# 2023 Recharge Master Plan Update

Chino Basin Watermaster

Project No. 941-80-22-11

Figure 4-3. Projected Annual Supplemental Water Replenishment and Recharge Requirements, 2023-2045

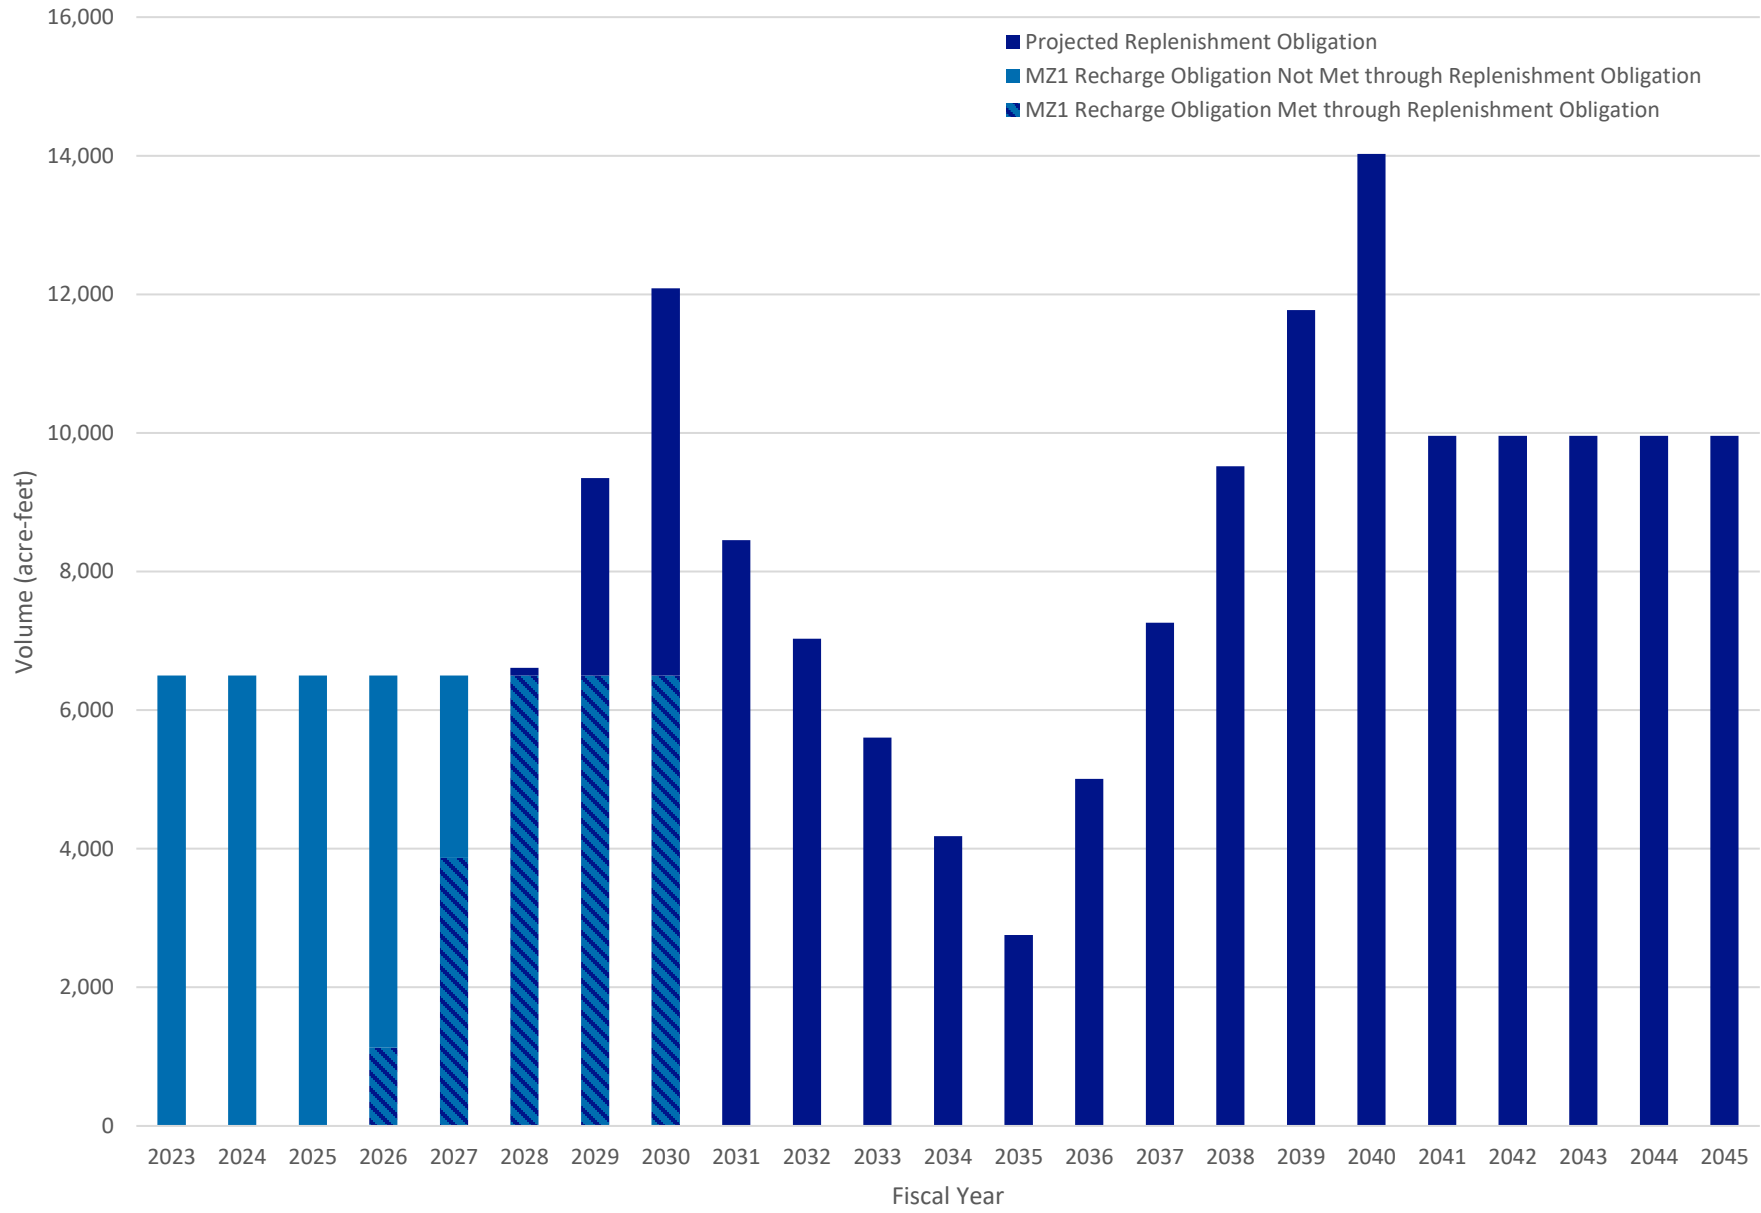
#### Comment 7 – Figure 4-3

**Comment 13 – Page 4-5: “Figure 4-3 also shows the 6,500 afy supplemental water recharge obligation for MZ1 through 2030.”.**

Figure 4-3 was updated to show that replenishment obligation is used to meet the MZ1 recharge requirement.
